KINGSTATE ELECTRONICS CORPORATION

PRODUCT CHANGE NOTICE: **KSSGJ4B20/ KSSJ4D20/KSSGI4B20-1**

VERSION: **TKS-7066-1.4/ TKS-7082-1.5/TKS-7273-1.2**

VERSION: **TKS-7066-1.5/ TKS-7082-1.6/TKS-7273-1.3**

1. KSSGJ4B20

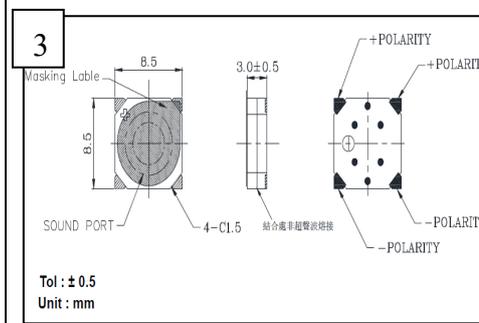
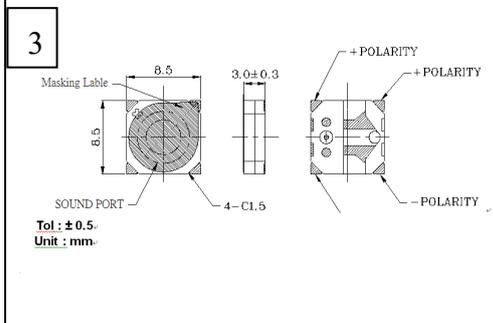
□□□□□□□□□□

The size remains the same.

2. KSSGJ4D20

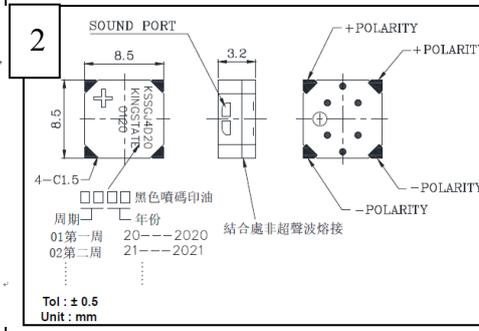
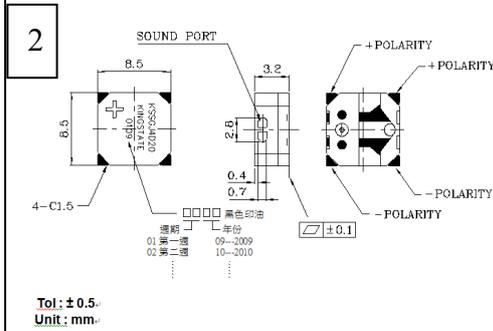
□□□□□□□□□□

The size remains the same.

3. KSSGI4B20-1

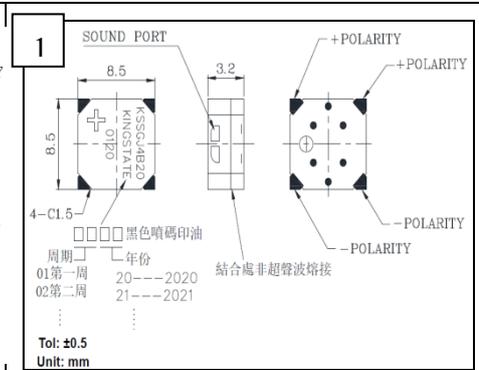
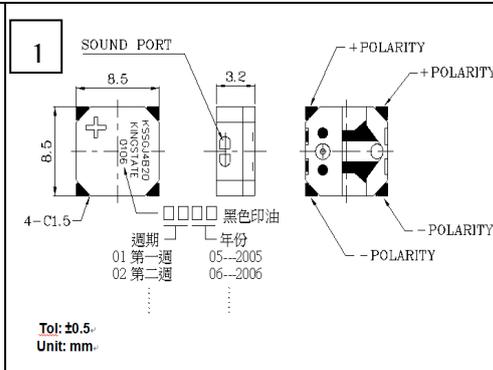
□□□□□□□□□□

The size remains the same.
